November 14, 2024

PROJECT NAME: FAMILY LIFE ASSEMBLY OF GOD SANCTUARY ADDITION

PROJECT NUMBER: 2024060054

APPLICATION: MAJOR SITE PLAN #31699

A MARION COUNTY MAJOR SITE PLAN
 FOR
FAMILY LIFE ASSEMBLY OF GOD
DAYCARE CENTER
Grading & Drainage Plan

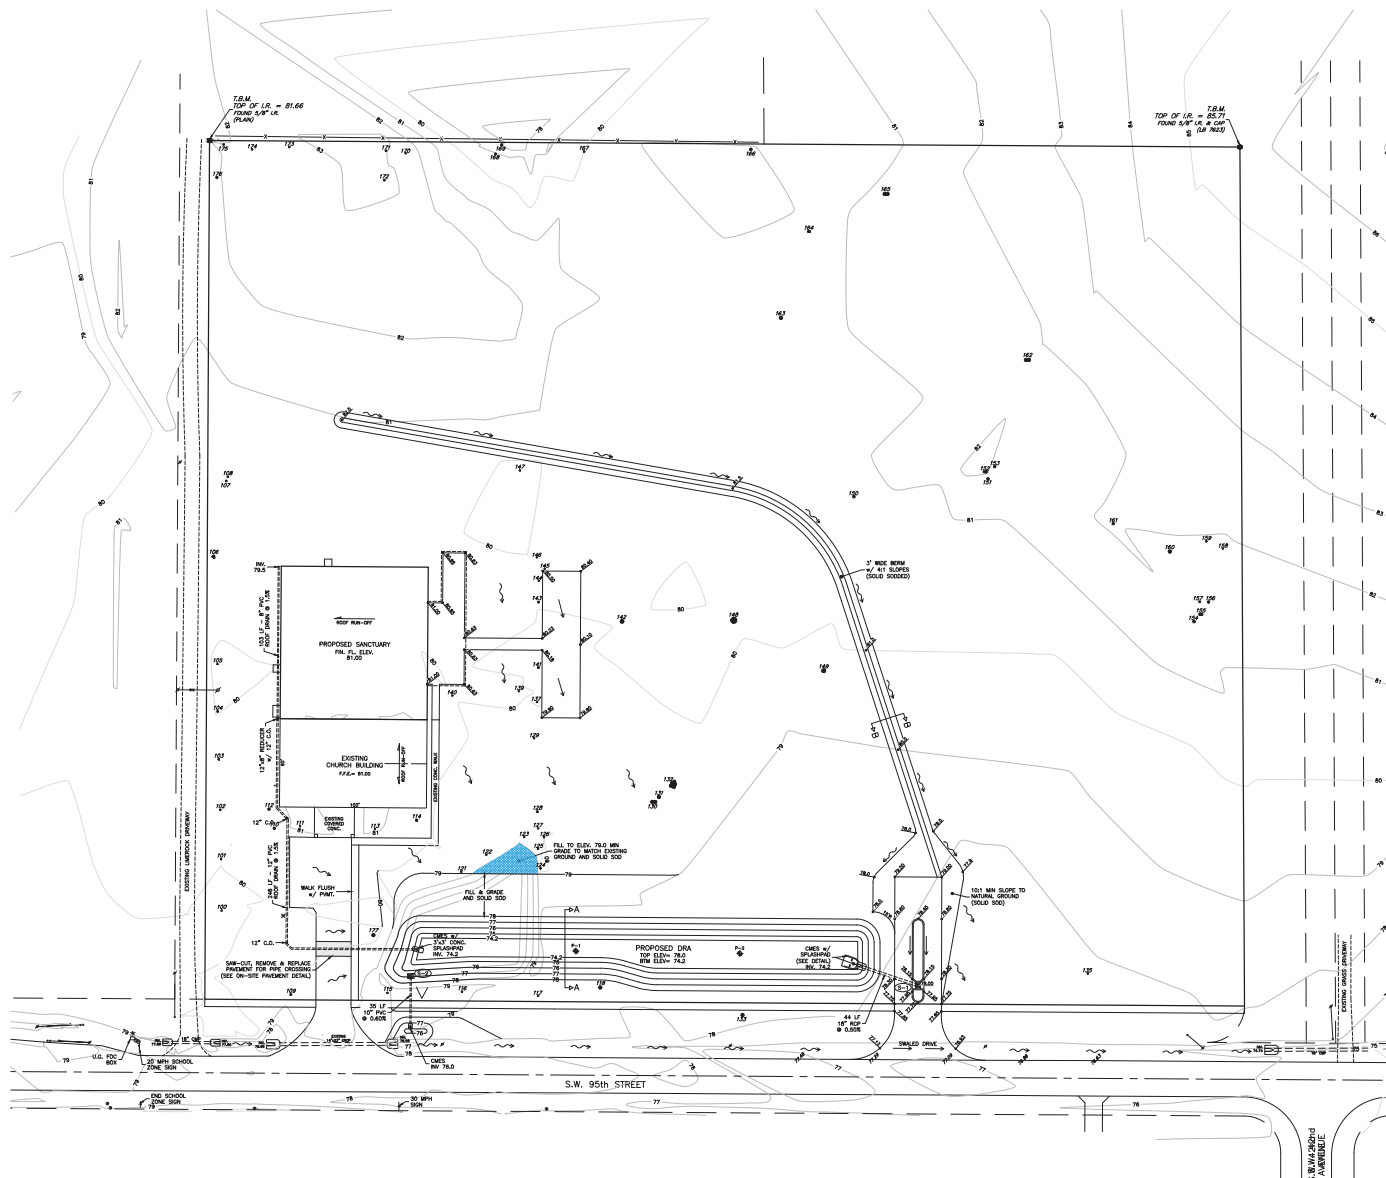
REMARKS: Minimum pipe size is 18" diameter. Staff would support a waiver provided supporting calculations. This is in reference to the pipe connected to structure S-2

- 20 DEPARTMENT: ENGDRN - STORMWATER REVIEW
REVIEW ITEM: 7.1.3 - Drainage Construction Specifications
STATUS OF REVIEW: NO
REMARKS: LDC requires the use of RCP pipe for stormwater conveyance piping. To pursue using an alternative material, the engineer needs to submit a request identifying the alternative material type requested, verification that the material is included on the FDOT Approved Products List, and the site specific installation meets install criteria such as depth of cover and UV protection for pipe ends. County will review the request and provide feedback. This is in reference to the pipe connected to structure S-2

Reason/Justification for Request (be specific): Request to allow 15" pipe pursuant to hydraulic calculations provided.

JOB No.
 34689-2024-01
 DATE
 8-06-2024
 SCALE
 1" = 40'
 SHEET
 006

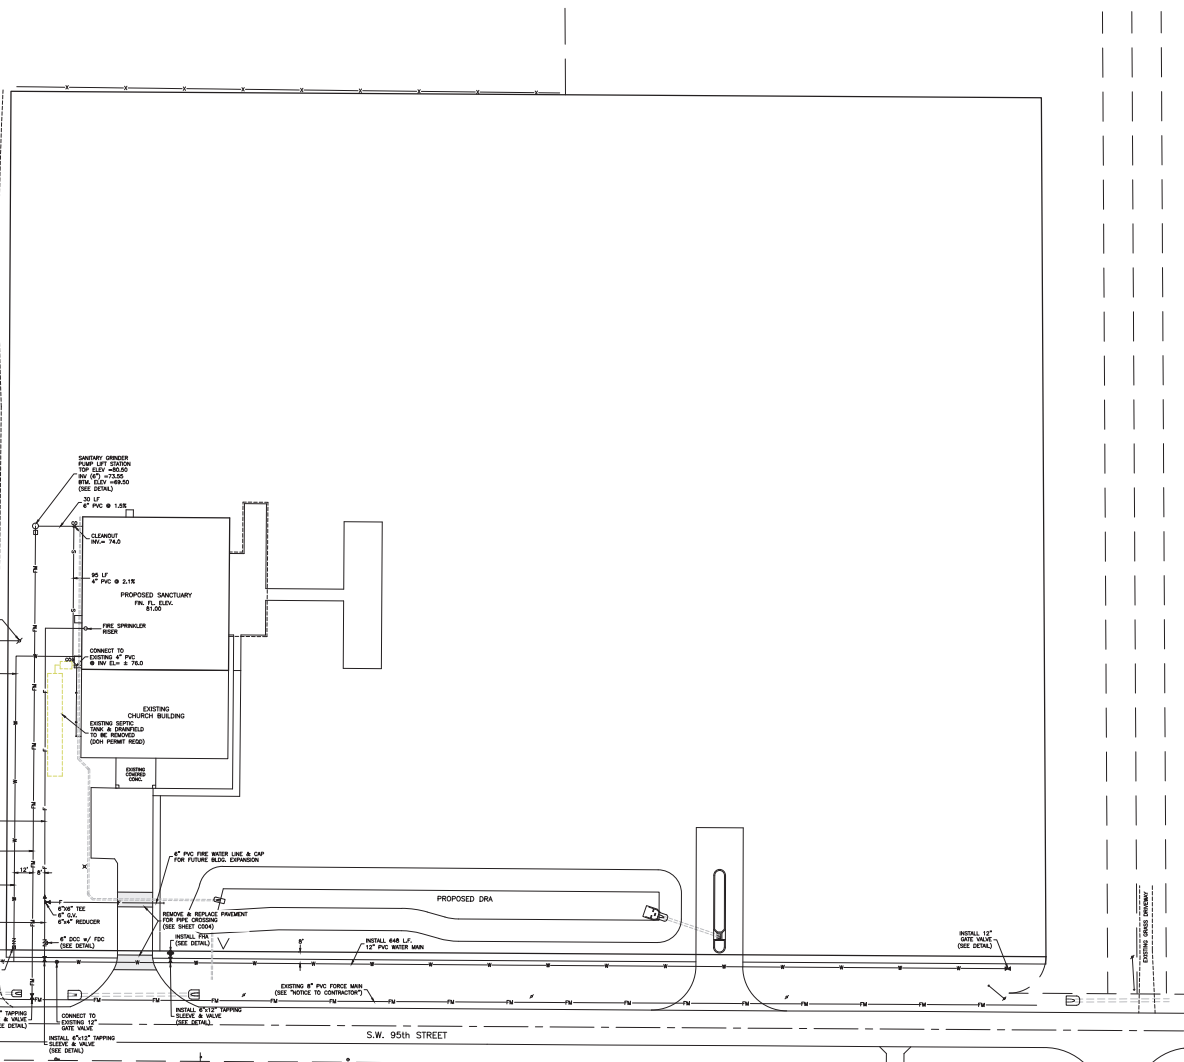
- 27 DEPARTMENT: UTIL - MARION COUNTY UTILITIES
REVIEW ITEM: 6.14.5.A(8) - Submittal Requirements - Connection to existing sanitary system
STATUS OF REVIEW: NO
REMARKS: Sheet C006 - install 316SS plug valve at property line (line of demarcation/end of county maintenance)

- 30 DEPARTMENT: UTIL - MARION COUNTY UTILITIES
REVIEW ITEM: 6.15.5 - Water Service and Connection
STATUS OF REVIEW: NO
REMARKS: Sheet C006 - install 2" manual blow off out of 12" cap

- 31 DEPARTMENT: UTIL - MARION COUNTY UTILITIES
REVIEW ITEM: 6.15.7 - Cross Connection Control and Backflow Prevention
STATUS OF REVIEW: NO
REMARKS: Sheet C006 need easement over DDC for meter maintenance

- 33 DEPARTMENT: UTIL - MARION COUNTY UTILITIES
REVIEW ITEM: Additional Utilities comments
STATUS OF REVIEW: NO
REMARKS: Cloud all revisions
- 34 DEPARTMENT: UTIL - MARION COUNTY UTILITIES
REVIEW ITEM: Additional Utilities comments
STATUS OF REVIEW: NO
REMARKS: Sheet C006 - SS Note #8 - lining is not necessary; note can be removed

JOB No. 38499-2024-01
DATE 8-06-2024
SCALE
SHEET 0007

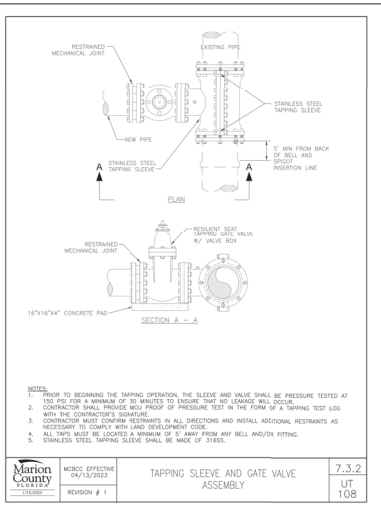
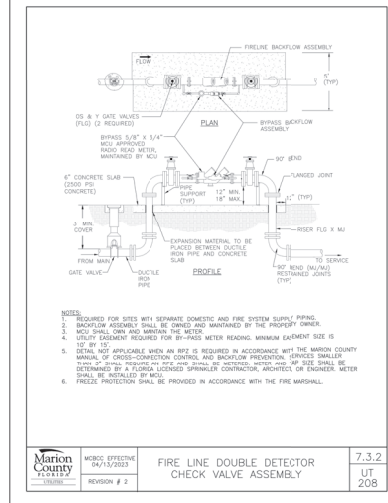
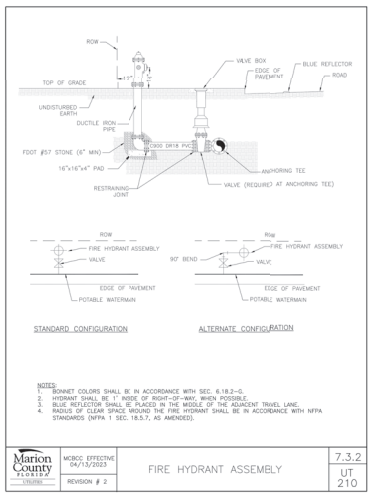
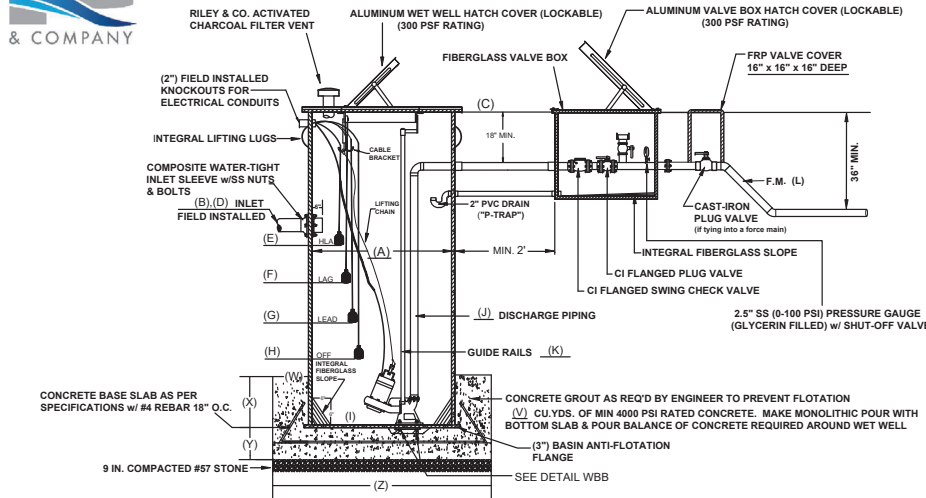
- 28 DEPARTMENT: UTIL - MARION COUNTY UTILITIES
REVIEW ITEM: 6.14.5.B - Construction Notes - UT DETAILS - current LDC version
STATUS OF REVIEW: NO
REMARKS: Sheet C007 - missing water main installation details

- 29 DEPARTMENT: UTIL - MARION COUNTY UTILITIES
REVIEW ITEM: 6.14.8.A - Completion and Closeout - PLAN NOTE: As-builts
STATUS OF REVIEW: NO
REMARKS: Sheet C007 - as-builts for water & sanitary sewer connections shall be supplied to Marion County Utilities & shall include all items referenced under this section of Code for CAD & .pdf versions. Allow 5 working day review time

LANDSCAPE PLAN
 FAMILY LIFE ASSEMBLY OF GOD
 MARION COUNTY
 FLORIDA

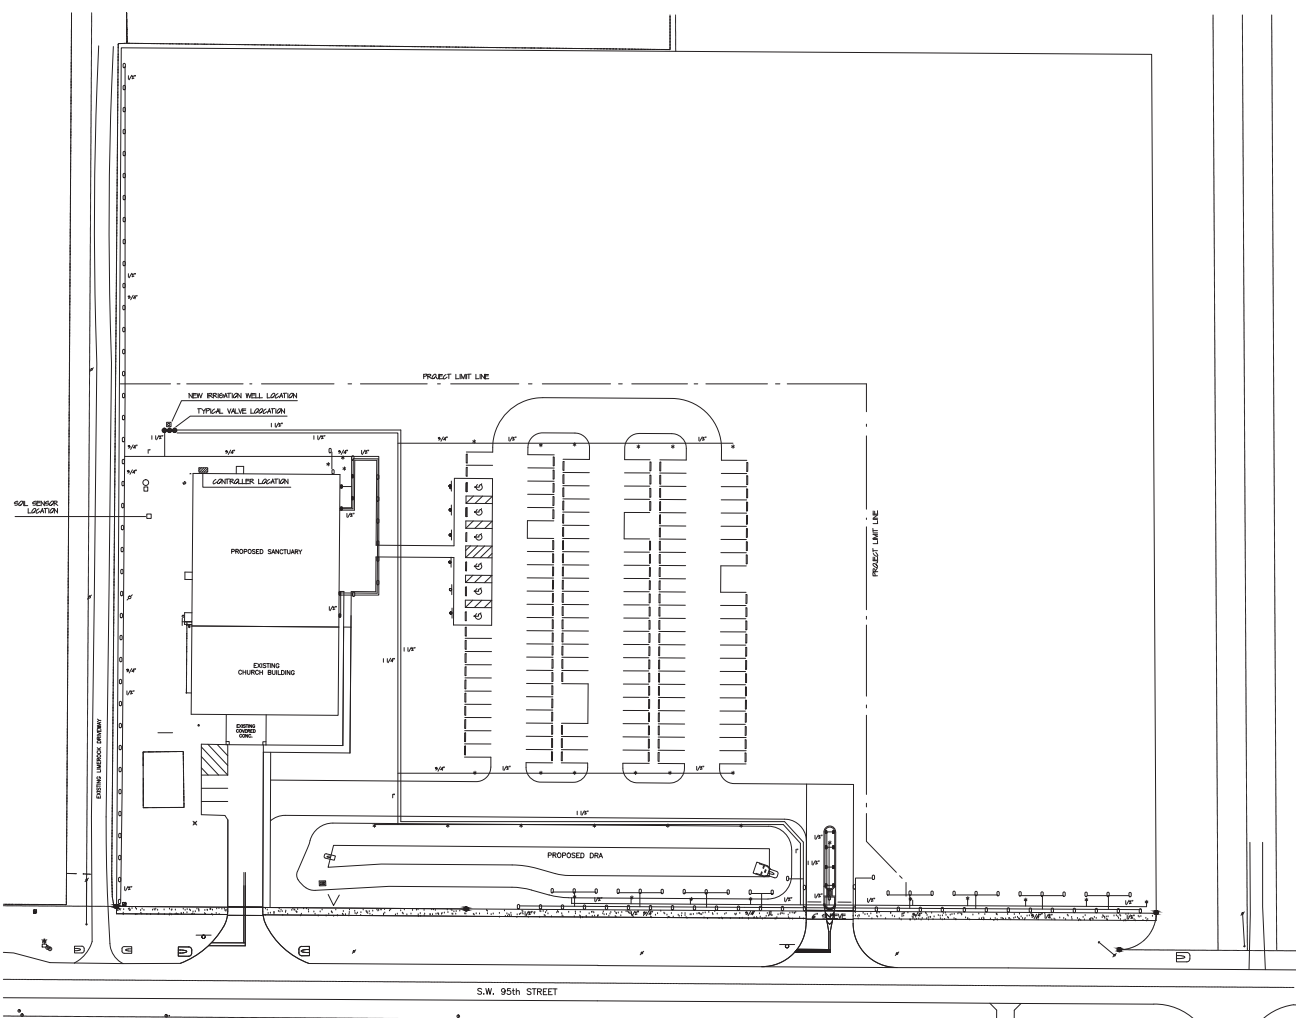
- 39 DEPARTMENT: LSCAPE - LANDSCAPE DESIGN AND IRRIGATION
REVIEW ITEM: 6.8.6 - Buffers
STATUS OF REVIEW: NO
REMARKS: 1. Please label existing shrubs to remain 2. Hamelia patens may be susceptible to cold, suggest more cold tolerant plant to avoid replacement 2. Some buffer trees along SW 95th are missing labels 3. Staff discussion regarding adjacent uses and buffers 4.

- 40 DEPARTMENT: LSCAPE - LANDSCAPE DESIGN AND IRRIGATION
REVIEW ITEM: 6.8.7 - Parking areas and vehicular use areas
STATUS OF REVIEW: NO
REMARKS: 1. A minimum five-foot wide landscape area consisting of shrubs and groundcovers, excluding turfgrass, shall be provided around the perimeter of parking areas to form a landscape screen with a minimum height of three feet achieved within one year of planting. 2. A landscaped parking lot island shall be located every ten parking spaces and shall be a minimum of 200 square feet in size with properly drained soils

Reason/Justification for Request (be specific): Request from interior island landscape and perimeter parking lot buffer due to grass parking lot is only used for one hour on Sundays.
